CANADIAN MUSEUM OF IMMIGRATION AT PIER 21 – EXPANSION

ADDENDUM 01
JULY 31, 2014

ARCHITECTURAL
MECHANICAL
ELECTRICAL

SK-1
1/A1.2.2

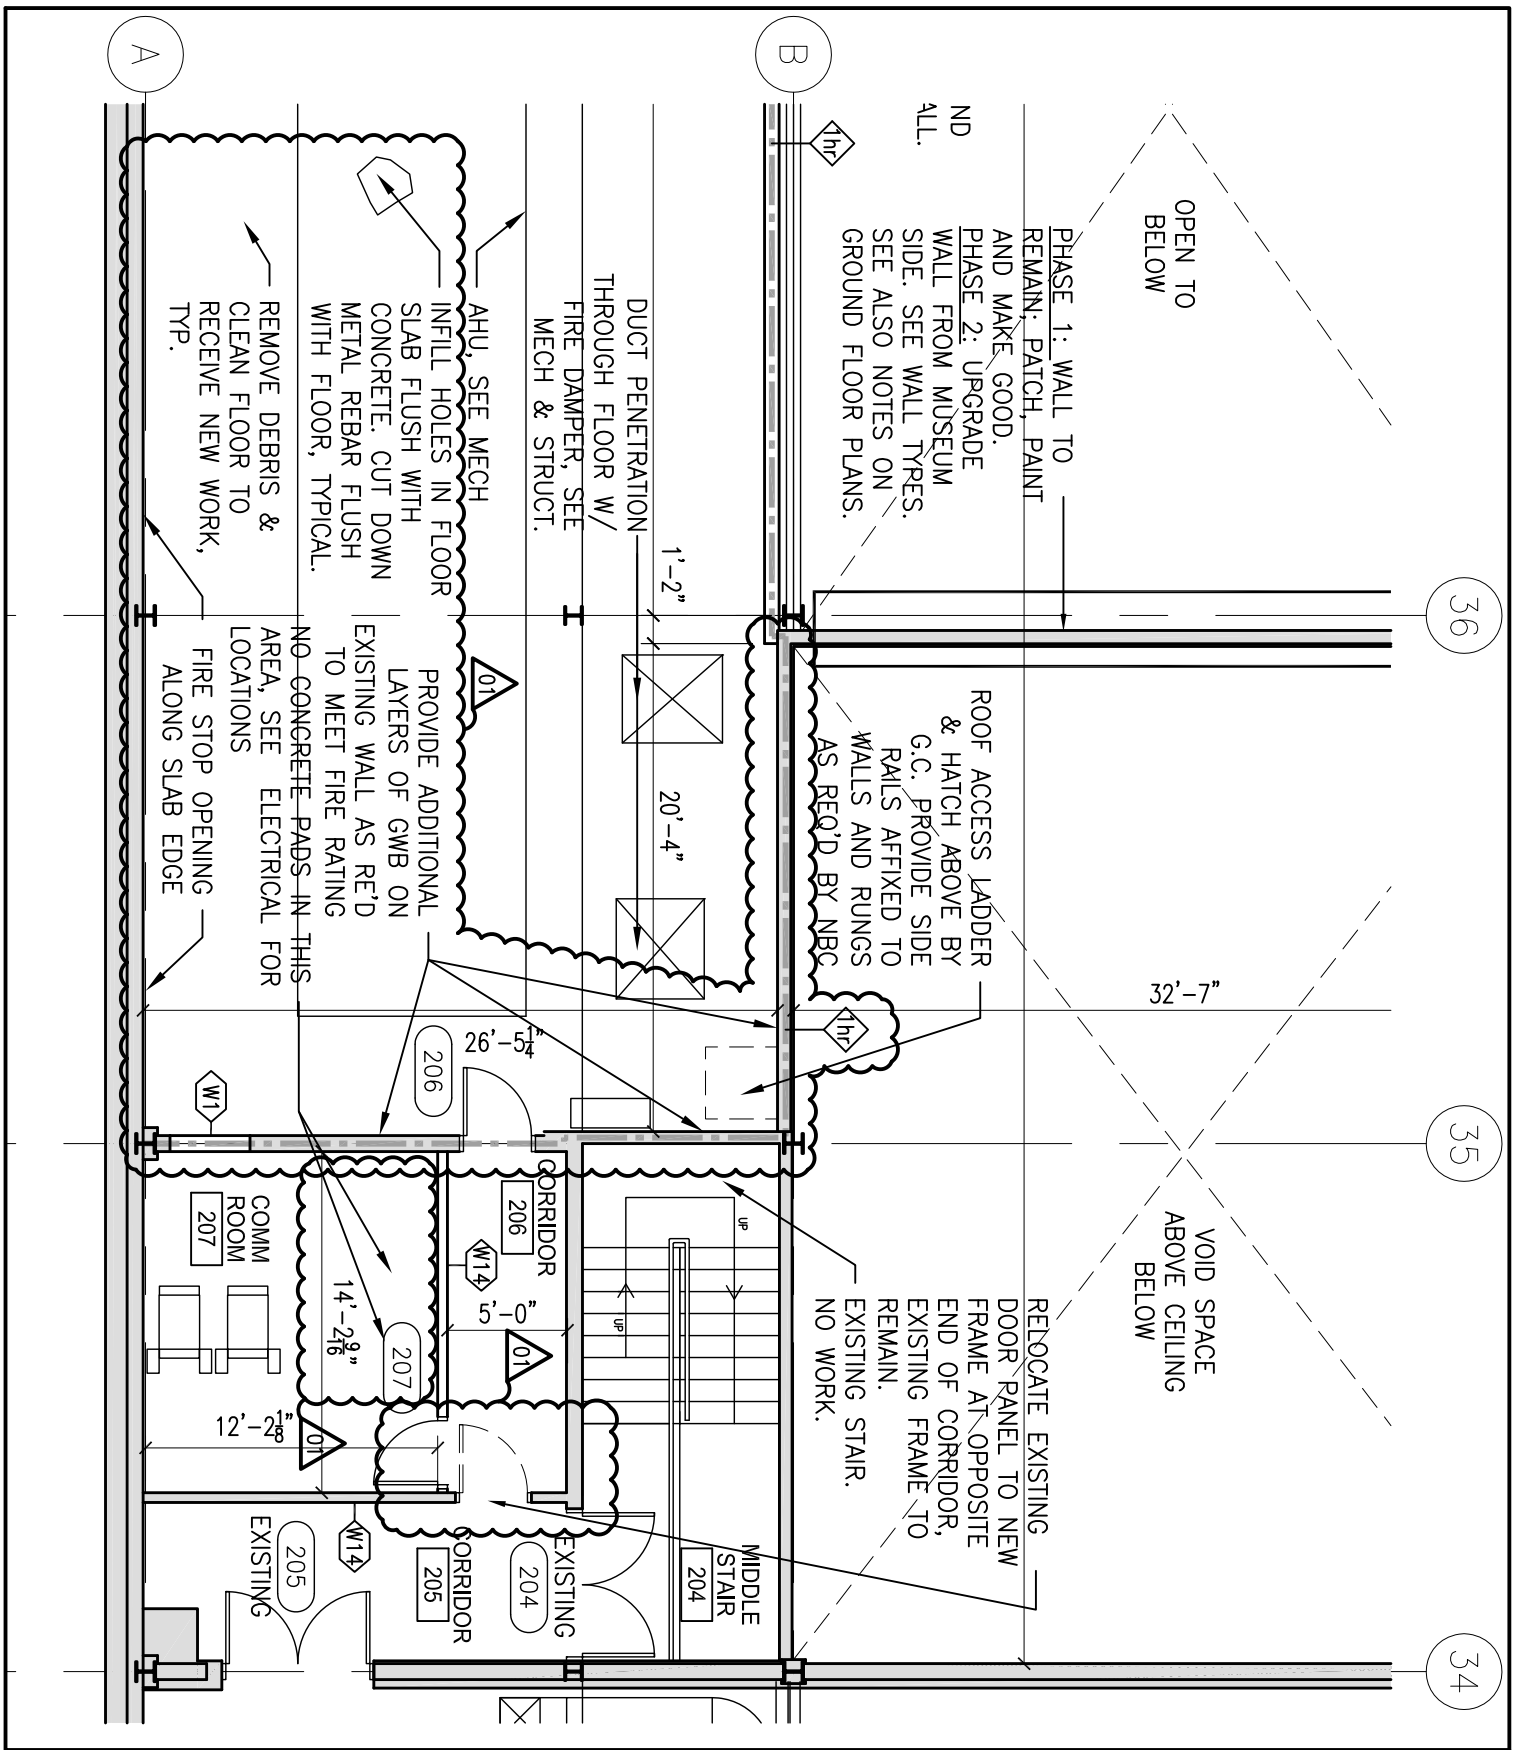
Architectural Revisions to Mechanical Mezzanine: see attached SK-1

Door 206 to be relocated (frame can remain), and placed in new 1hr rated frame to be installed at other end of corridor. Please find attached SK-1. Wall and door assembly to be 1hr rated as shown on SK-1. This will require additional drywall to achieve the rating on this wall.

- Existing concrete floor to be cleaned and washed. Existing holes in floor to be filled, and existing rebar / metal that sticks up from floor needs to be removed.
- Any gaps along exterior wall between building envelope and concrete floor requires Fire Stopping to provide a 1hr separation.
